Overview

Staff's Role

Drawdown Analysis

Figure 7. Theis Recovery Analysis for the Big Gulch Stock Well with Revised Water-Level Trend Correction

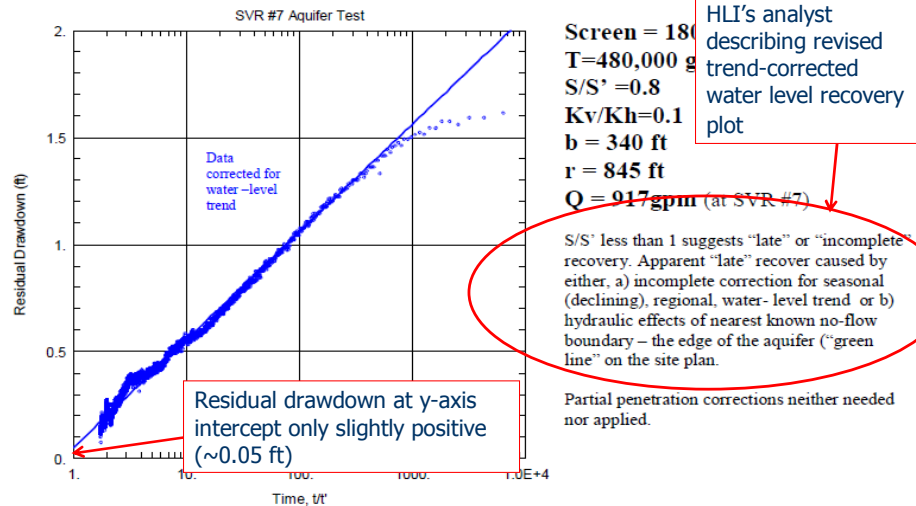
Here then is Figure 7 from the Response to the Staff Memorandum, Exhibit 45. This figure is a plot of the water level recovery data from the Big Gulch Stock well after applying the revised correction, which you'll recall is based on analysis of data that were collected in this same well after the test had been conducted. With the revised correction, the residual drawdown at the y-intercept is only slightly positive, approximately five hundredths of a foot. Nonetheless, HLI's analyst again acknowledges the possibility of late or incomplete recovery but this time indicates that it was "caused either by: a) incomplete correction for seasonal, declining, regional water-level trend, or b) hydraulic effects of nearest known no-flow boundary, the edge of the aquifer green line on the site plan."

EXHIBIT 44

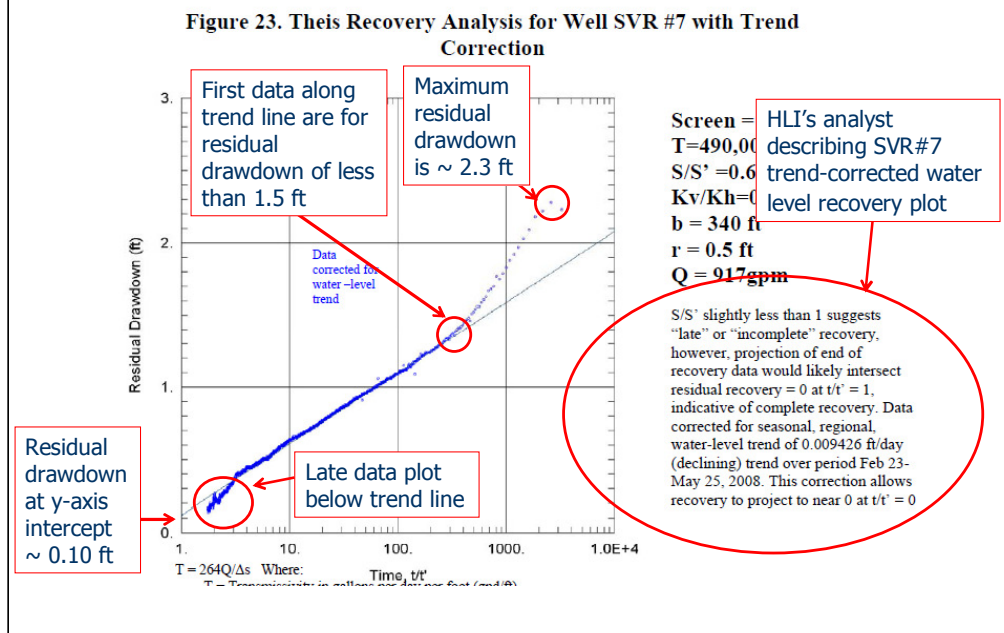
This is Figure 23 from Exhibit 44, which purportedly is a plot of trend-corrected recovery data from the SVR#7 pumping well. Note that the trend-corrected residual drawdown at $t/t' = 1$ for the pumping well is approximately one-tenth of a foot, which is somewhat larger than for the Big Gulch Stock well. Again the caption acknowledges that the recovery appears to be late or incomplete based on the trend line but, unlike in the case of Figure 27 for the Big Gulch Stock Well, the analyst considers late data that don't plot along the trend line in concluding "*projection of the end of recovery data would likely intersect residual recovery = 0 at $t/t' = 1$, indicative of complete recovery.*" Beyond pointing out this inconsistency in the treatment of the late recovery data, the reason that I wanted to drag everyone through this rather difficult material is to emphasize that the regional water level trend corrections that were applied to the recovery data effectively mask the true response of the aquifer. In other words, the drawdown that was caused by pumping in the two wells with the most drawdown, SVR#7 and the Big Gulch Stock well, is not of sufficient magnitude in relation to the various water level correction factors to definitively assess whether or not the aquifer recovery was delayed or possibly even incomplete. The fact that uncertainty about the regional water level trend was used to explain residual drawdown intercepts of both 0.05 feet and 0.25 feet in the Big Gulch Stock well and 0.1 feet in the nearby SVR#7 well supports the idea that, in the case of the SVR#7 test, where the maximum recoveries are only on the order of a foot or two, a well-specific regional trend analysis based on data that were collected after the test makes evaluation of aquifer boundary conditions using the water level recovery data tenuous. Based on this figure, it is our opinion that the aquifer was not stressed enough by pumping at 900 gal/min for 9 days to facilitate a more definite analysis of the recovery data.

Before we move on from Figure 23, I want to point out that the first data points to plot along the trend line, which I've circled in red, are for residual drawdown values of slightly less than 1.5 feet and the maximum residual drawdown value of any data point is approximately 2.3 feet, which I've also circled in red.

The 2.3-foot maximum residual drawdown suggests that there may be a problem with Figure 23, which again is the trend-corrected water level recovery plot for the pumping well during the 9-day SVR#7 aquifer test. Table 2 from Exhibit 44, the SVR#7 aquifer test report indicates that the maximum measured drawdown in the pumping well was 29.79 feet and that, after correcting for well loss, the maximum drawdown in the pumping well was 7.51 feet. The 2.3-foot maximum residual drawdown on Figure 23 is therefore more than 5 feet less than the maximum drawdown after correcting for well loss. This rather large and unexplained discrepancy suggests to staff that the data shown in Figure 23 may not be representative of water levels in the pumping well during recovery.

EXHIBIT 67

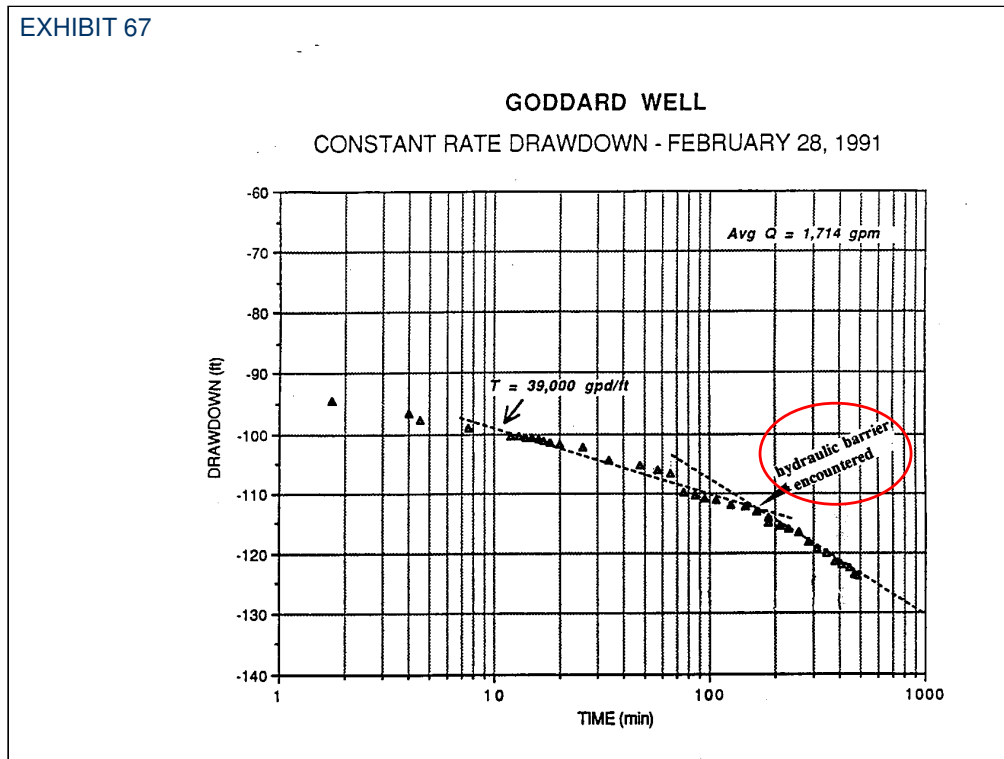
Squires, Wood, and Osiensky documented that the 551-foot deep Goddard #2 well is impacted by a hydraulic barrier (i.e., no-flow) boundary in their 1992 report entitled Hydrogeologic Framework of the Boise Aquifer System, Ada County, Idaho (Exhibit 67). They also presented an aquifer test data plot for the Goddard #2 well and identified the point on the curve where there was an increase in the slope of the drawdown trend as indication of a negative hydraulic barrier. According to HLI's Response to our Staff Memo, Goddard No. 2 is a PGSA well (Exhibit 45, p. 27) so there apparently is some sort of flow barrier in the PGSA between M3 and the postulated recharge area. As I mentioned earlier, Goddard #2 nonetheless has been in production for more than a decade so my concern is not that this well taps into a hydraulically isolated portion of the aquifer, but rather that M3's numerical model might not be an accurate predictor of impacts since it does not simulate this hydraulic barrier.

EXHIBIT 67

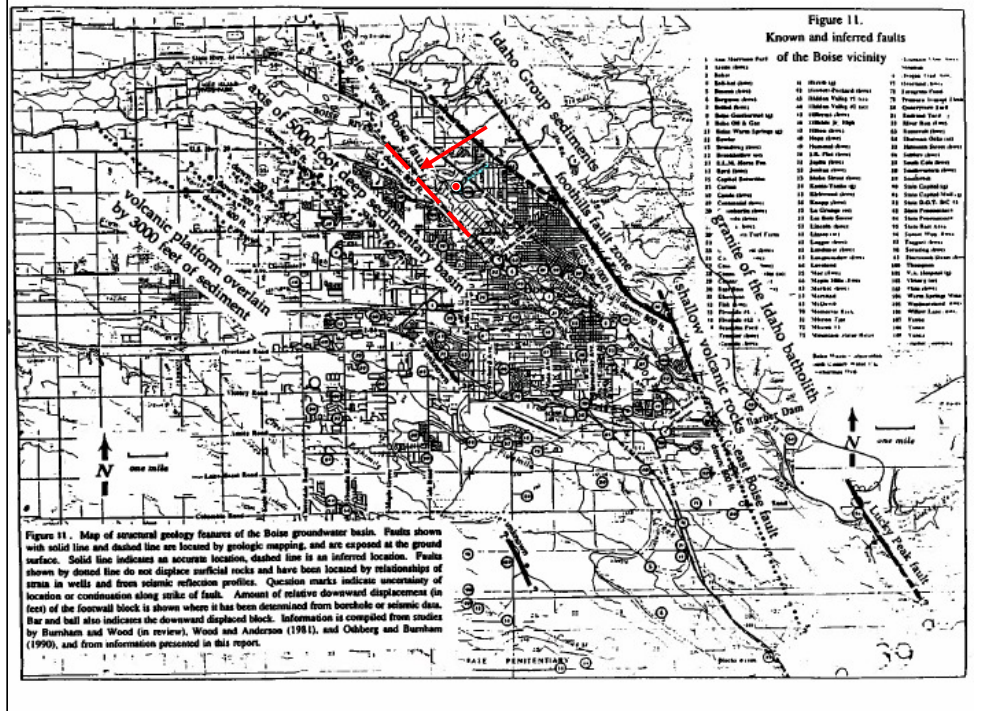
However, inspection of Figure 11 within the 1992 report, Exhibit 67, suggests that the Swift well, which I've identified with a small red dot, is on the upthrown side of the West Boise/Eagle fault, which I've emphasized with a dashed red line. The estimated offset across the fault is 800 feet, which is indicated on the left side of the fault trace below the large red arrow. If this is the case, hydraulic communication between this newly identified recharge area near the Swift well and the PGSA at M3 likely is limited by the fault.

EXHIBIT 2

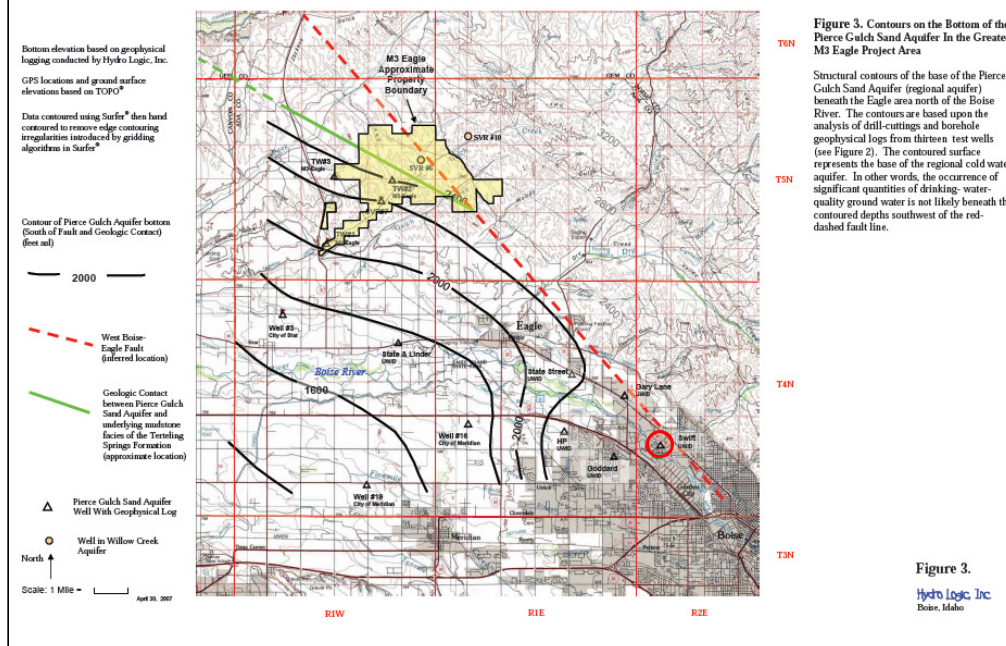
4 - in HLI's 2007 report (Exhibit 2), the Swift well, which I've circled in red, is located on the downthrown side of the West Boise-Eagle fault on the map showing the extent of the bottom of the PGSA. Note that the fault is located on the northeast side of the Boise River near the Swift well on this figure. This indeed suggests that there may be hydraulic continuity between the PGSA at M3 and beneath Garden City, but, as previously discussed, this fault location is different than shown on the map in the 1992 Report (Exhibit 67).

EXHIBIT 19D

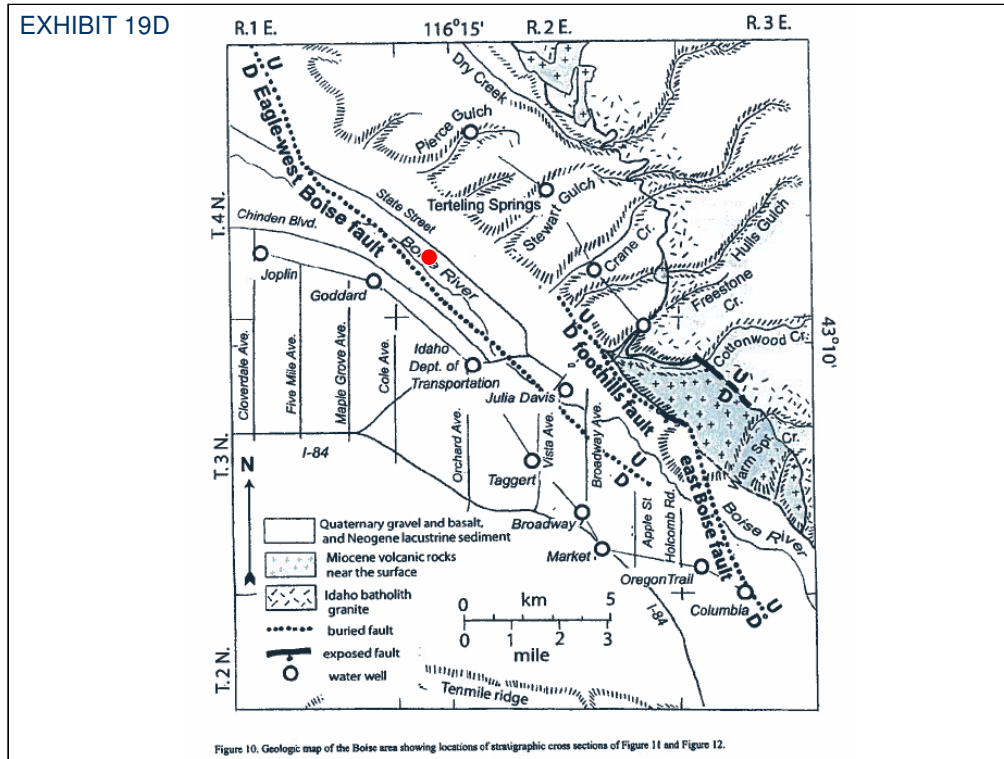
Like the 1992 report, the Wood and Clemens 2002 Report, Exhibit 19D, shows the Eagle-West Boise fault to be on the southwest side of the Boise River near the Swift well, which I've identified on Figure 10 with a red dot. We are not aware of any new data that justify relocating the West-Boise Eagle fault from its mapped location, albeit approximate, in the 1992 and 2002 reports.

Figure 4. Hydrogeologic Cross Sections based on Deep Exploration Well Borehole Geophysical Analyses (from Wood)

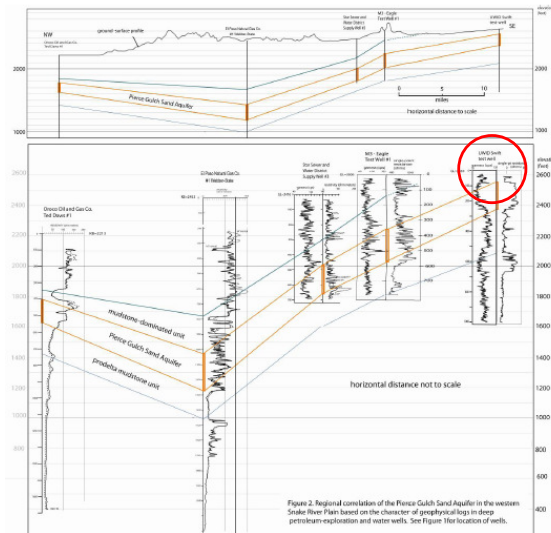
5 - the driller's log, and the near-surface geophysical signature for the Swift well, which I've circled in red in the upper right corner of Figure 4 from Exhibit 45, indicate that there is at least 30 feet of blue clay on top of what HLI identified as the PGSA. The surficial clay layer shows up as a kick to the right on the gamma log, which is the left strip chart in the area that I've circled, and a deflection to the left on the resistance log, which is the strip chart on the right. If laterally continuous, that clay layer would limit hydraulic communication between the PGSA and the alluvial aquifer system. As discussed by Mr. Glanzman, the geochemistry data indicate that PGSA groundwater has not had much contact with clay, which also suggests that communication with the Boise River is not significant in the vicinity of the Swift Well.

EXHIBIT 2

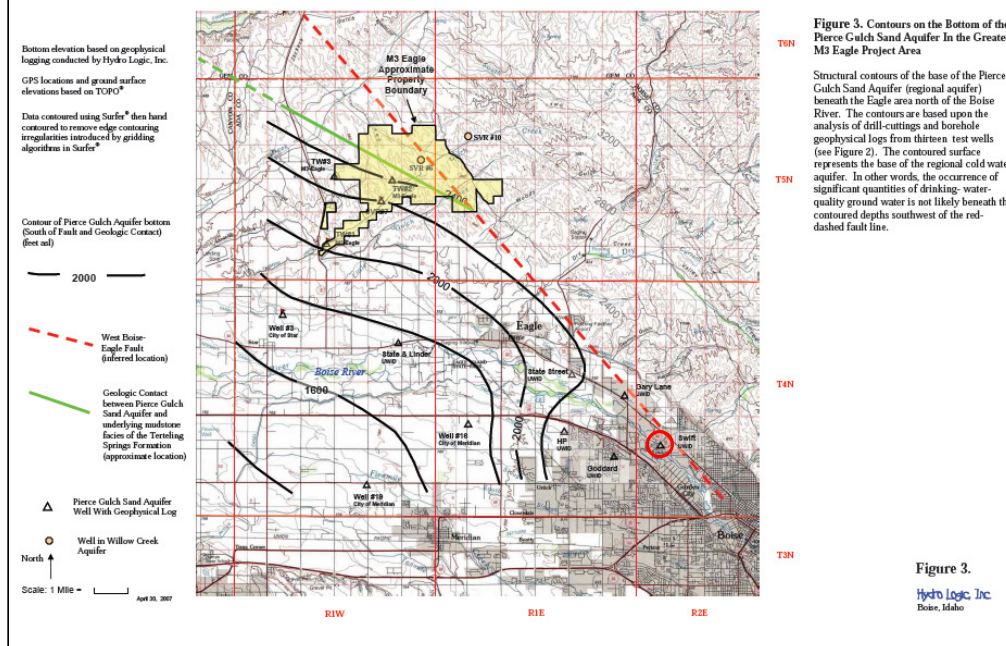
6 - the figure showing the bottom of the PGSA in HLI's 2007 report, Figure 3 from Exhibit 2, does not show contour lines east of the Garden City Fairgrounds or south of Cloverdale Avenue. The contours also do not extend west beyond the Canyon/Ada County line or into Gem County. The lateral extent of the PGSA shown on this figure based on geologic data is therefore considerably smaller than the modeling domain of the M3 numerical model.

Figure 1. Map showing M3 property, geologic mapping in progress, and location of magnetometer lines. Center point of magnetic anomalies are circled - refer to text for discussion.

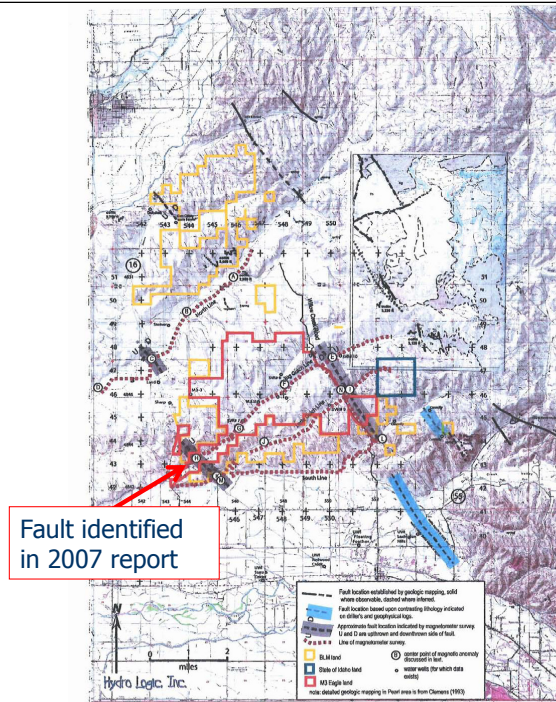
Let me be clear on this point, Hydrology Staff does not know whether there is fault gouge, or fine-grained sediments infilling the fault plane, or offset of the PGSA across the fault that was mapped by Wood in his 2007 report, Exhibit 19B, and we also don't know whether and, if so, how much any of those factors affect groundwater flow. We do know, however, that faults can and do exert control on groundwater in aquifers beneath the western Snake Plain and elsewhere, acting as partial, and in some cases, more-or-less complete barriers to flow. That's why we're so interested in understanding the location and hydrologic functioning of faults in North Ada County and why we've commissioned BSU's Center for Subsurface Geophysical Investigation to conduct a seismic study using a larger seismic source than was previously used. BSU's lead investigator would like to get started within the coming month.

Figure 88. Theis Analysis for TW#1 Zone 1 – Kling Irrigation Two-Day Test
Test Conducted: January 9-11, 2007

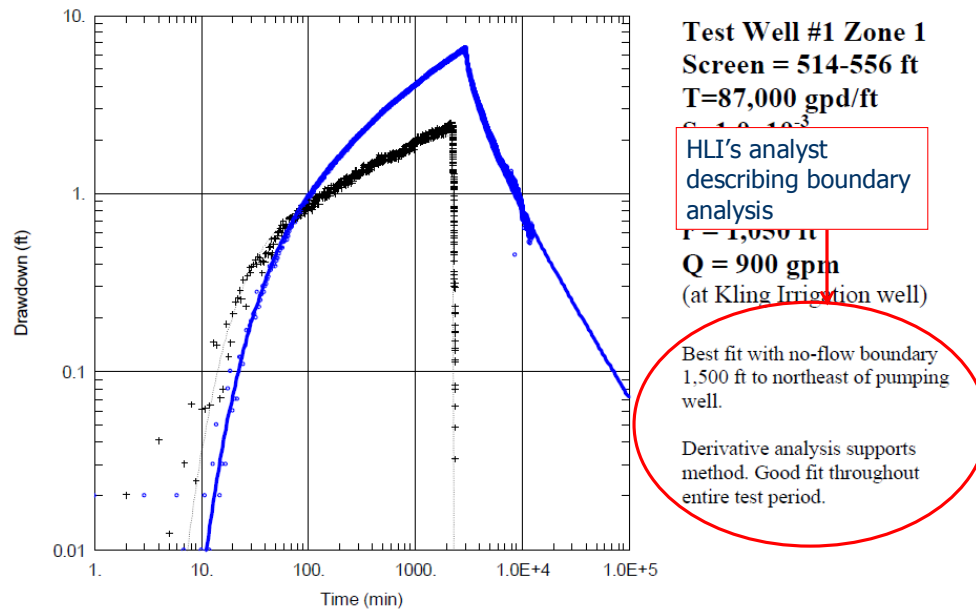
Here's a copy of a drawdown data plot from the Kling irrigation well test. It's Figure 88 from Exhibit 12. I want you to notice the notation that's been highlighted with a red circle. It says "*Best fit with no-flow boundary 1,500 feet to northeast from pumping well*". And then below that it says, "*Derivative analysis supports method. Good fit throughout entire test period*". I really don't see how it can be considered speculative on the part of staff to think that the fault that was identified by Wood in the panhandle of M3's property approximately 1,500 feet northeast of the Kling irrigation well acts as a no-flow boundary, when it was HLI's own analyst that first proposed the idea in a submittal to the Department.

Figure 2. Subsurface Seismic Reflection Profiles (from Wood)

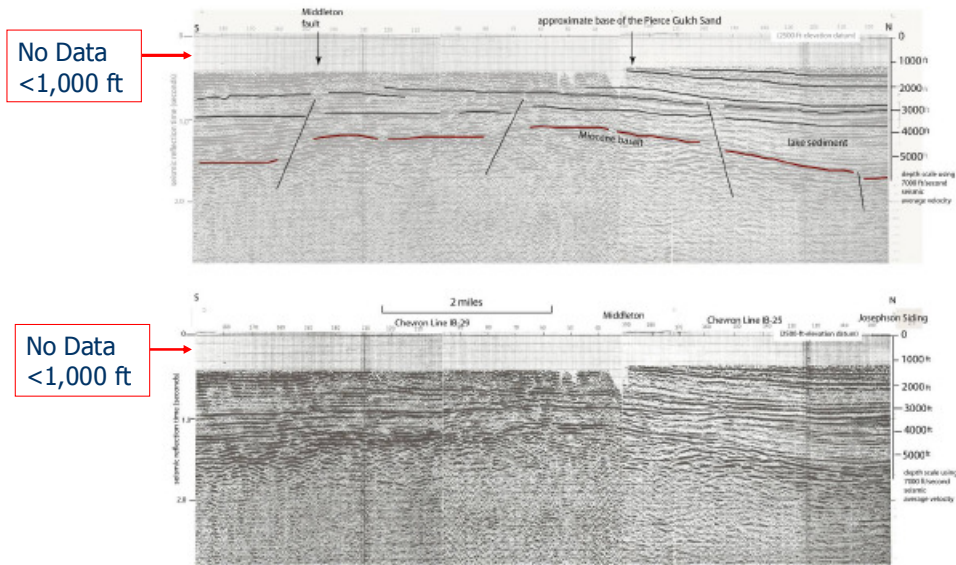
Inspection of Figure 2 reveals that it can't be used directly to support that argument since the beginning depth of the profile is greater than 1,000 ft. There simply are no data in the shallow section that includes the target aquifer. Indeed, the deep faults aren't shown as propagating to land surface on this figure but, based on the information in one cross-section that doesn't extend into the shallow section, it's unclear whether the understanding of the hydrogeologic significance of shallow faults has improved since the 1992 report, which, at that time, described the level of understanding as poor.
